Addendum No. 1
April 29, 2019

Project: First PREMIER Bank
Bid Package #2
Sioux Falls, South Dakota
#2764

Architect: Architecture Incorporated

1 6" STOREFRONT DETAIL 2/5.17
 SD-3 SCALE: 1/4" = 1'-0"

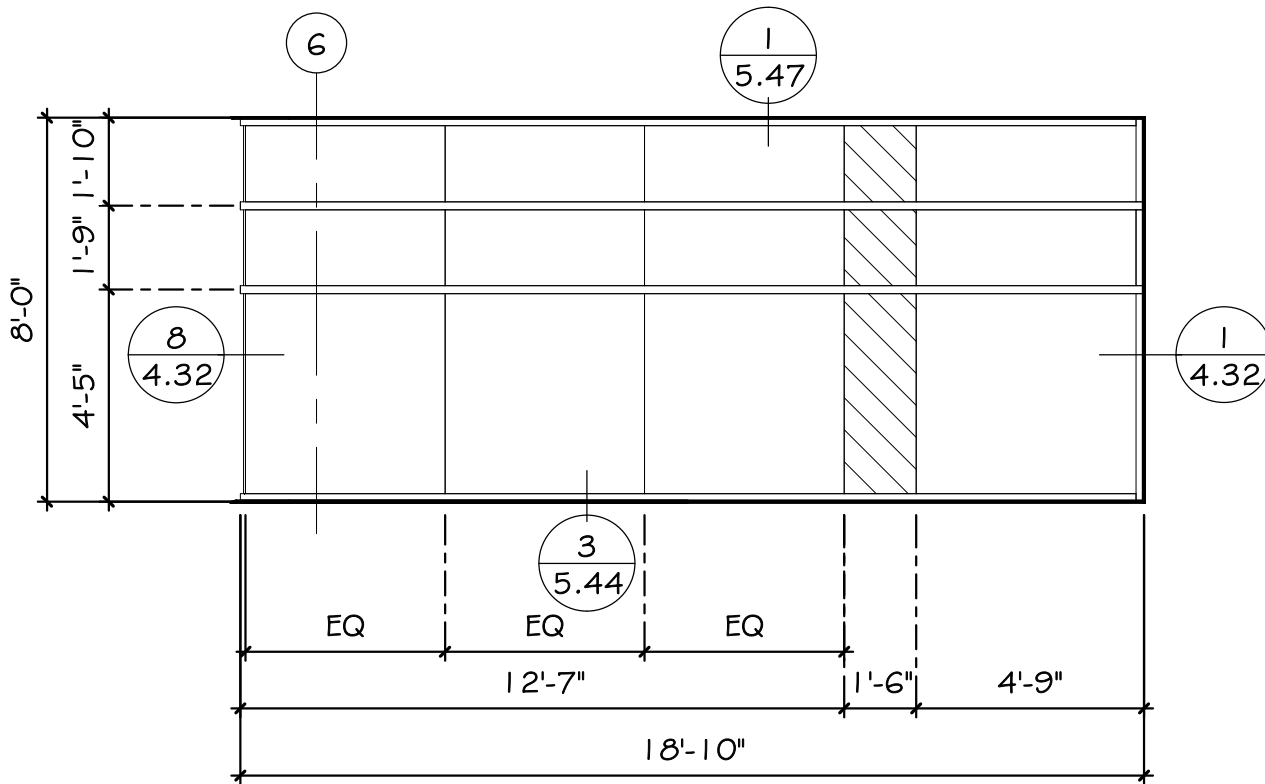
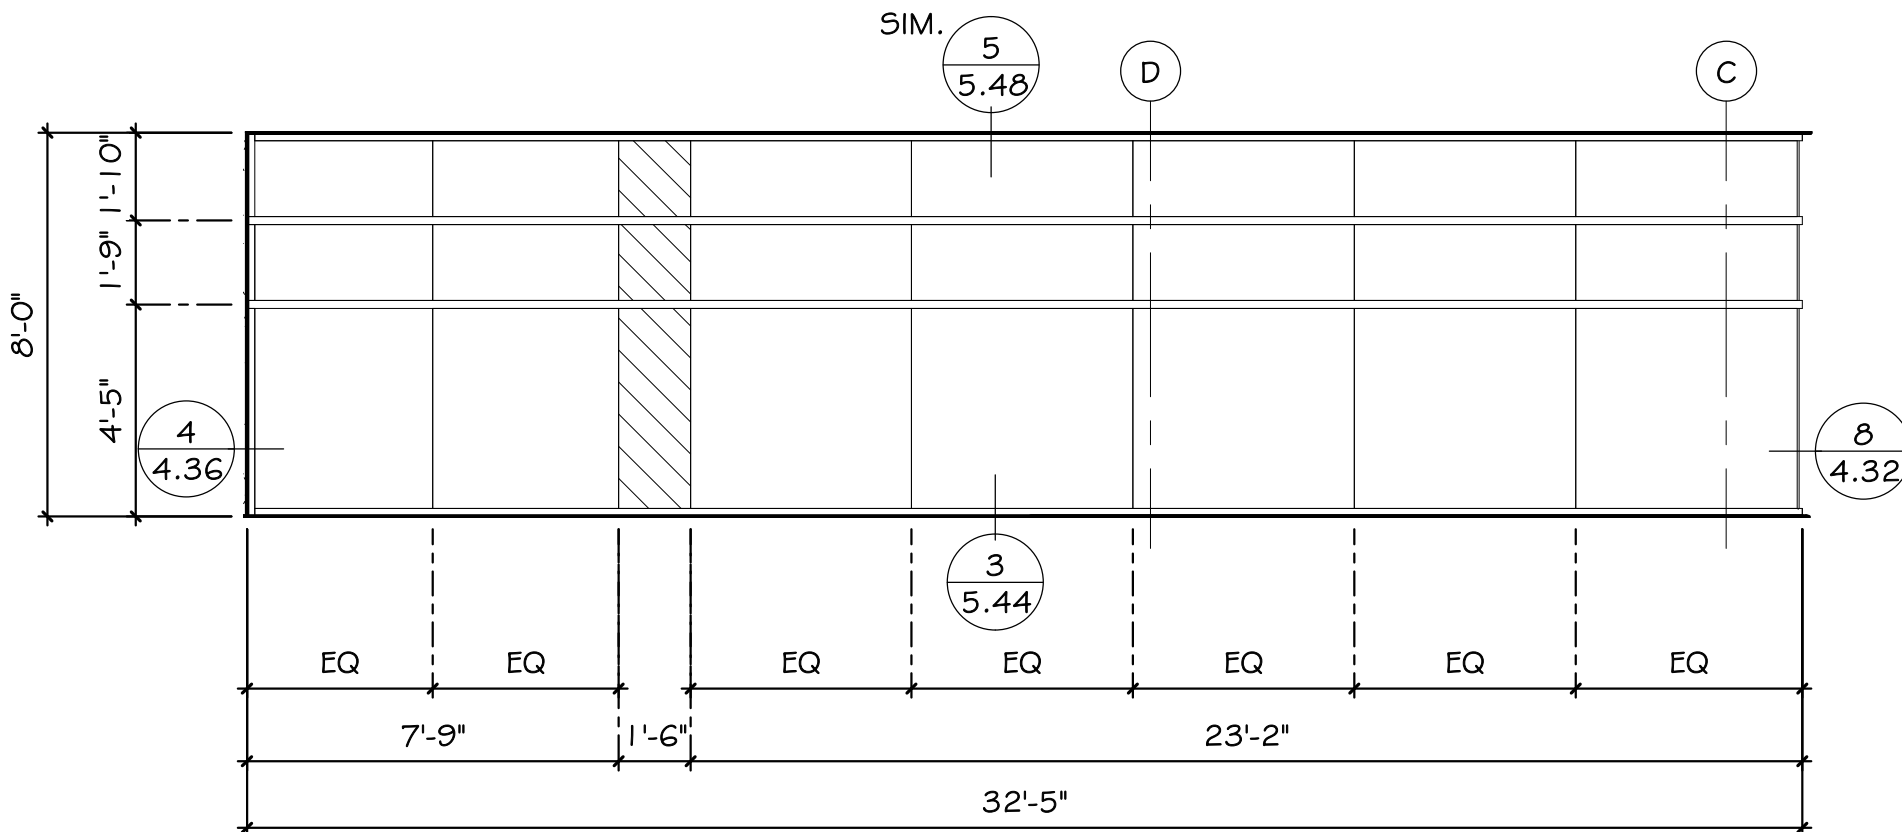
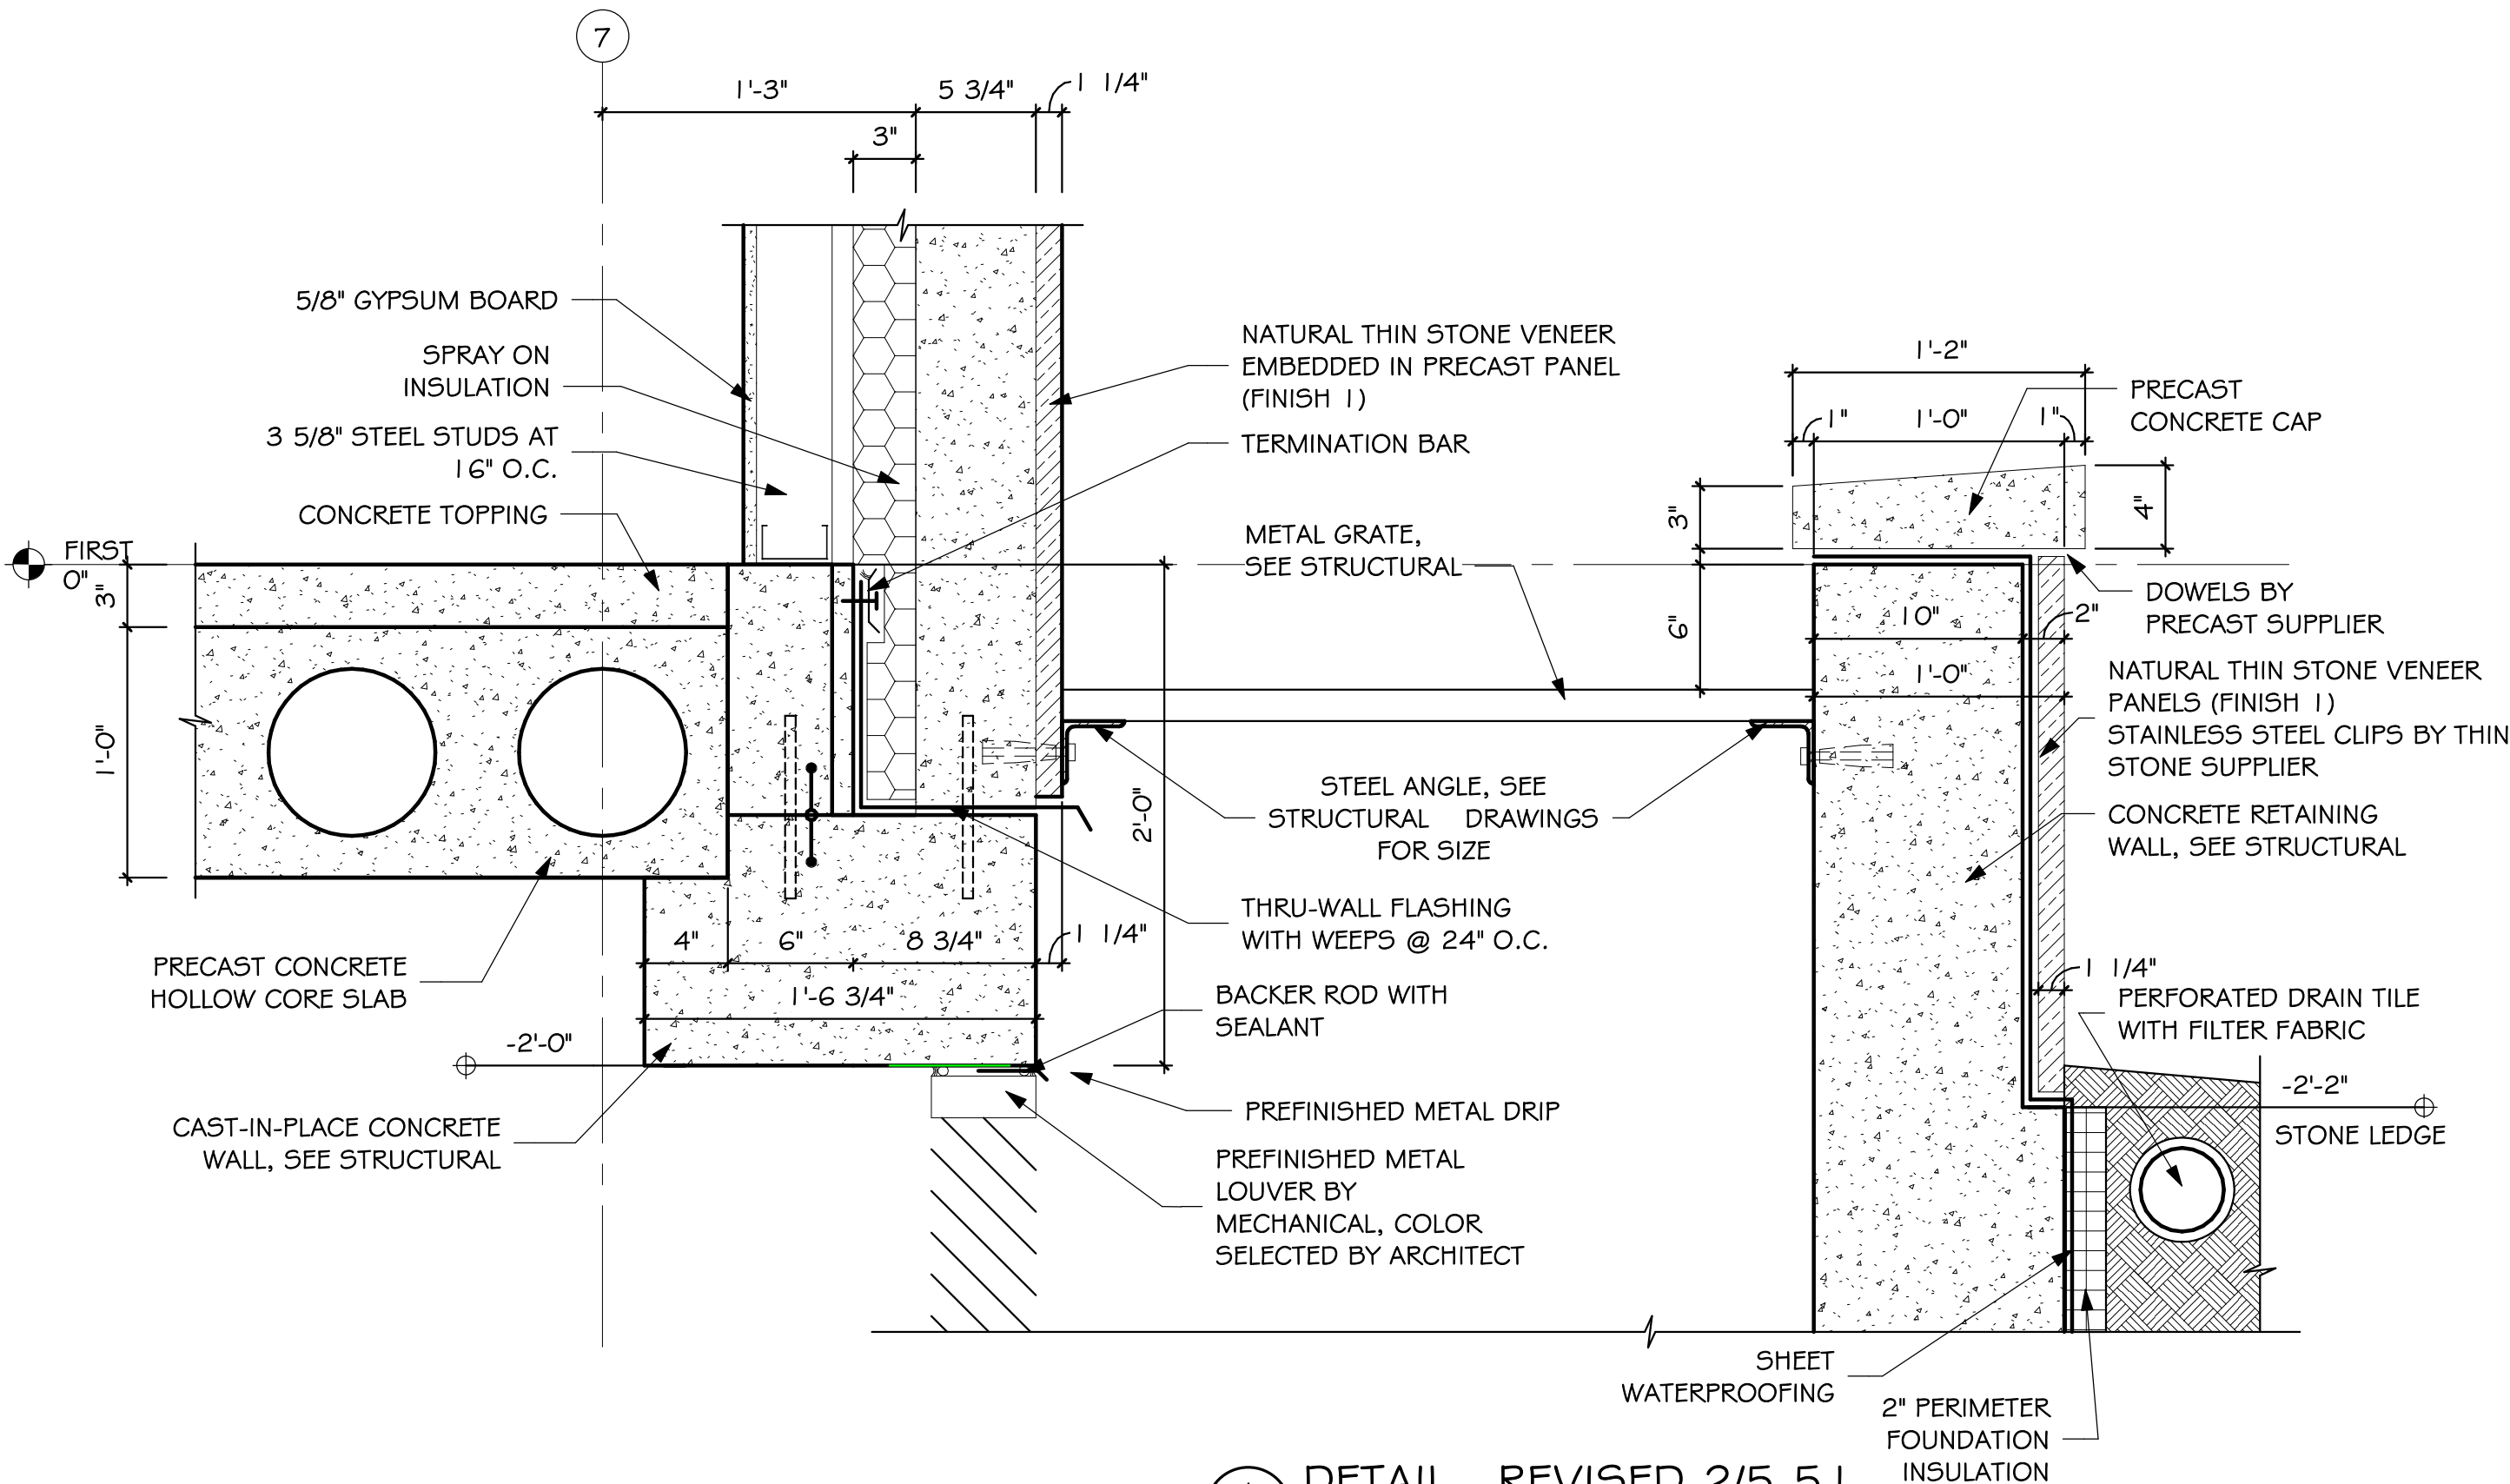
- a) Detail 2/5.17 – Reference attached SD-3 dated 04/25/2019 for revisions to detail 2/5.17.
- b) Provide 6” depth Curtainwall system at all elevations noted as 6” STOREFRONT.

- a) Detail 13/5.18 – Reference attached SD-3 dated 04/25/2019 for revisions to detail 13/5.18.
- b) Provide 6” depth Curtainwall system at all elevations noted as 6” STOREFRONT.

1
 SD-4
 DETAIL - REVISED 2/5.5 1
 SCALE: 1 1/2" = 1'-0"

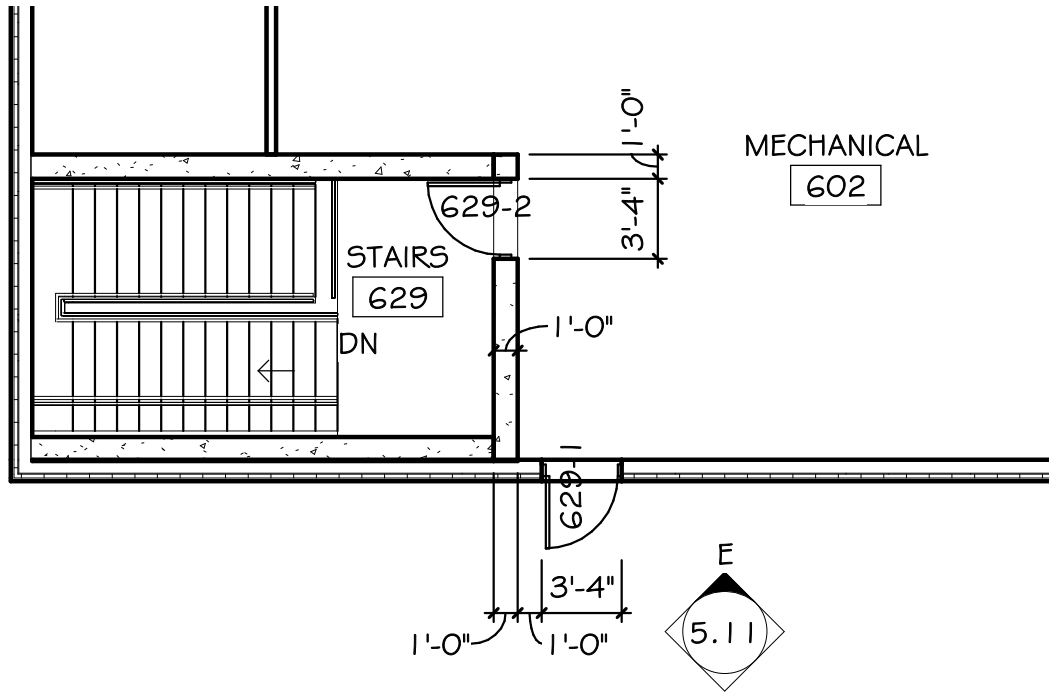
- a) Reference drawing SD-4 dated 04/26/2019 for changes to the areawell stone veneer, detail 2/5.51.

1 PARTIAL SOUTH PENTHOUSE PLAN
SD-5 SCALE: 1/8" = 1'-0"

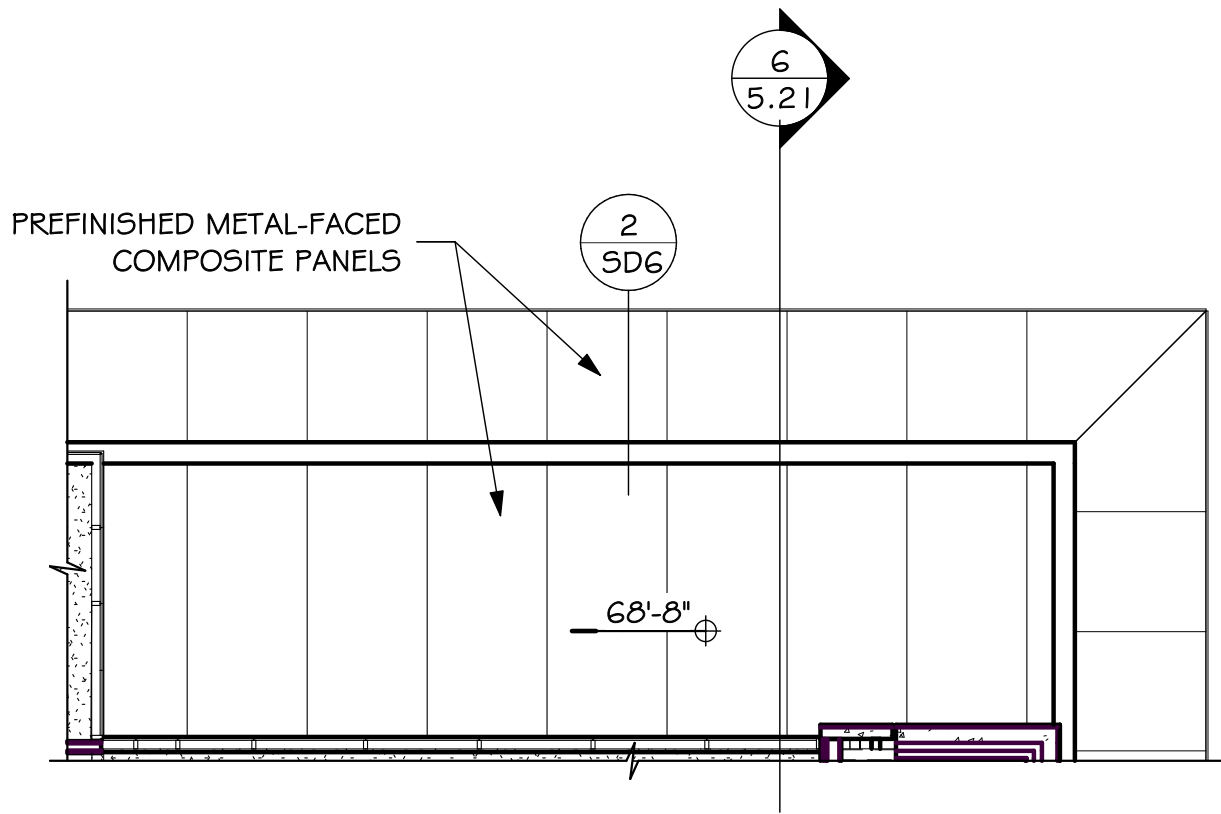
- a) South Penthouse – Reference attached SD-5 dated 04/25/2019 for revisions to the location of door 629-1.

2 DETAIL - REVISED 3/5.45
SD6 SCALE: 1 1/2" = 1'-0"

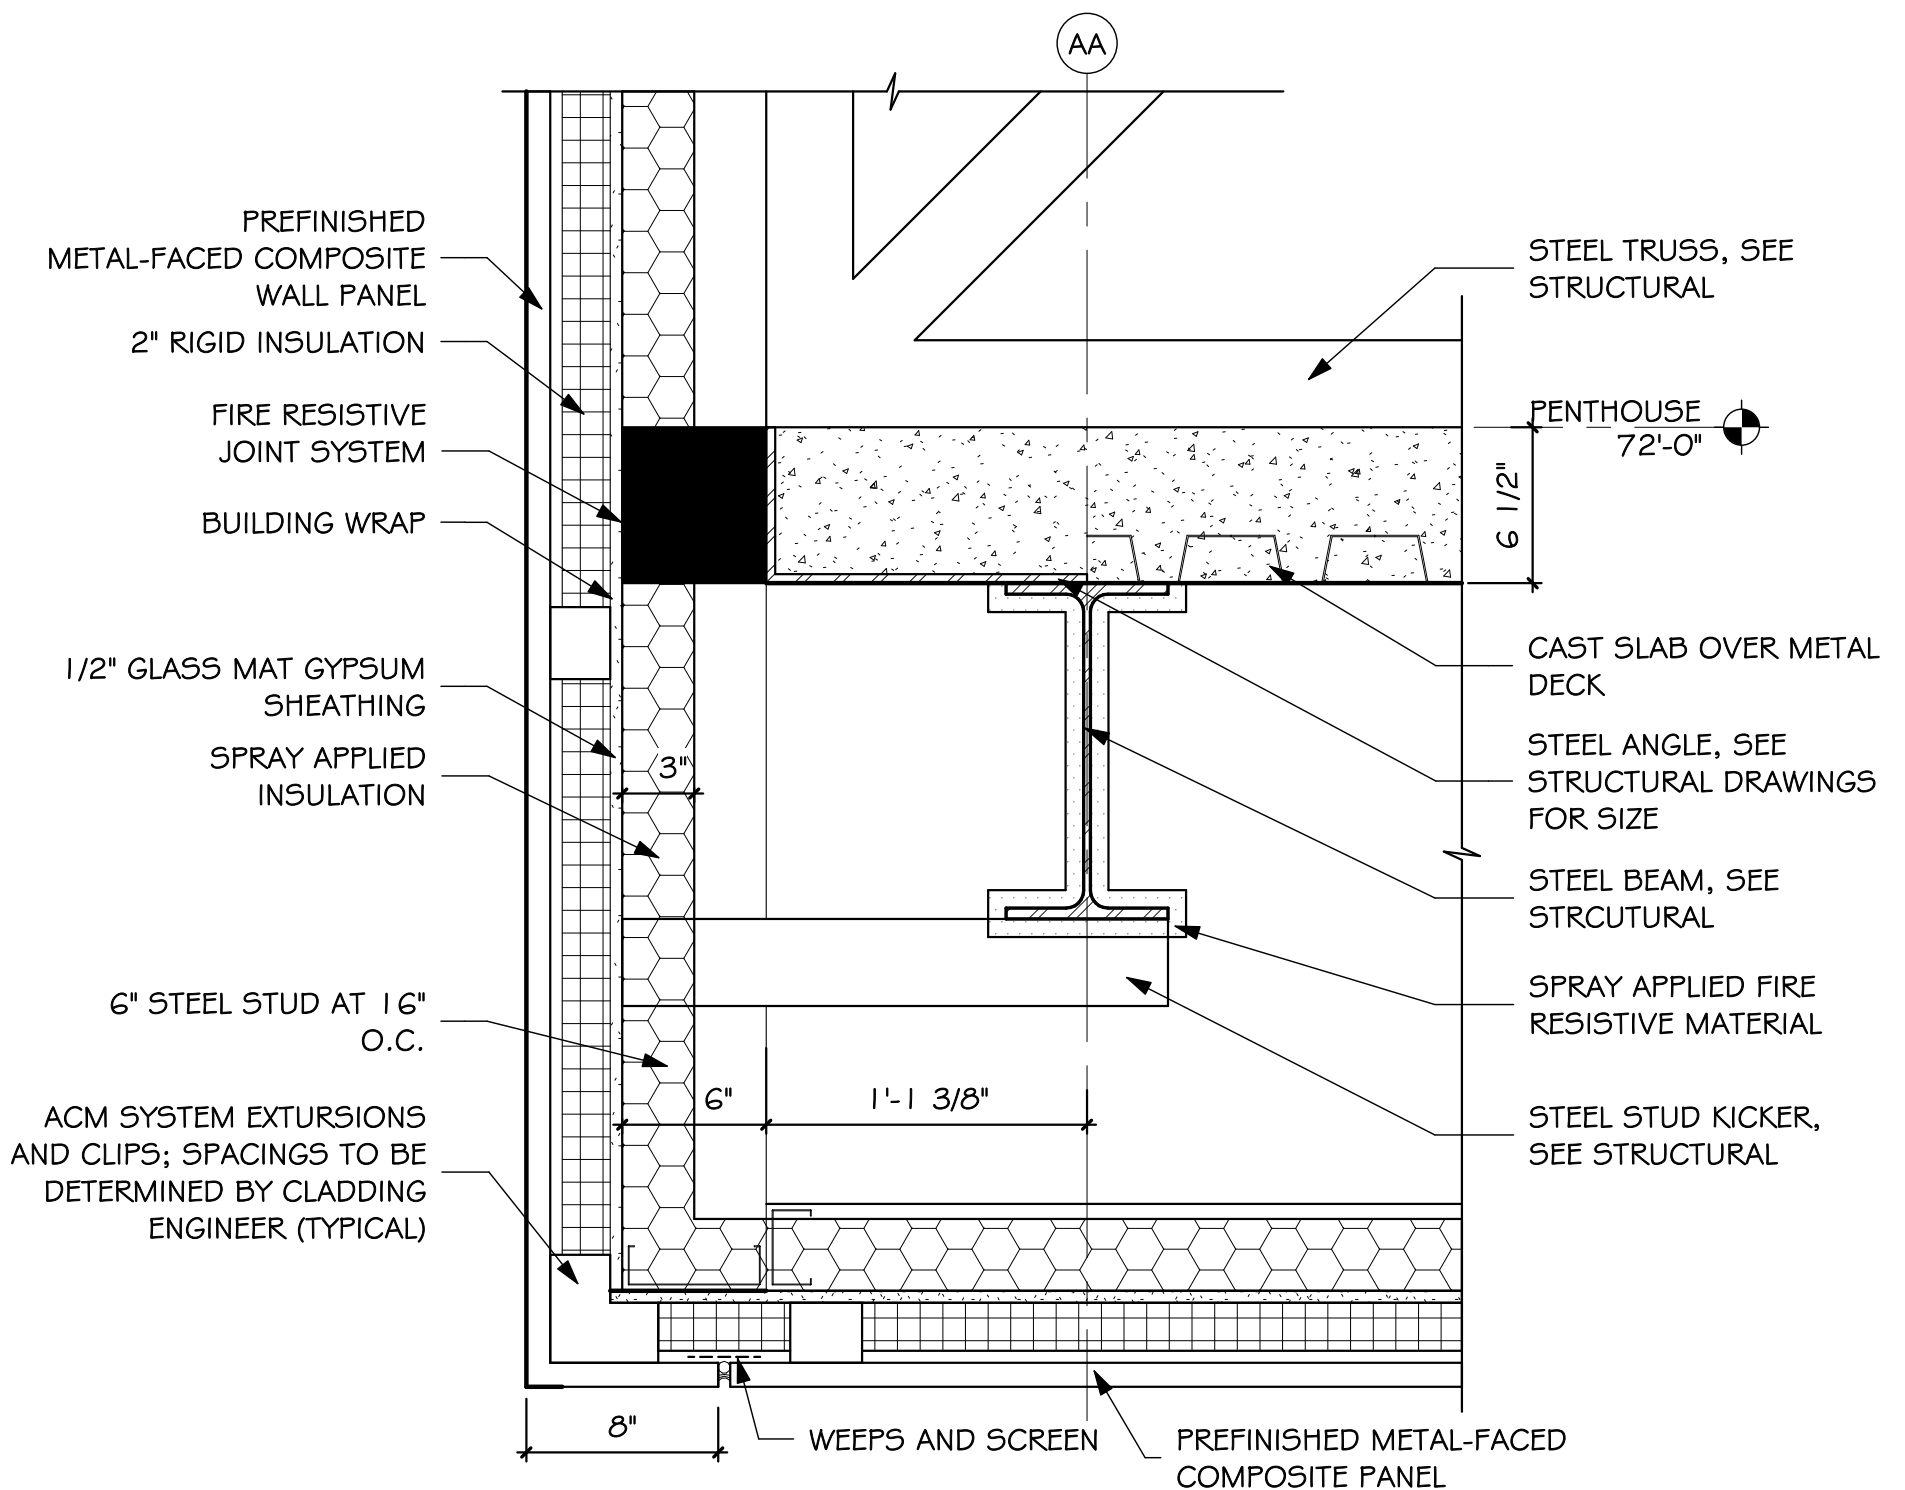
- a) Reference drawing SD-6 dated 4/29/19 for changes to detail 3/5.45. The soffit panel is to be Prefinished Metal-Faced Composite Panel in lieu of prefinished metal soffit panel.
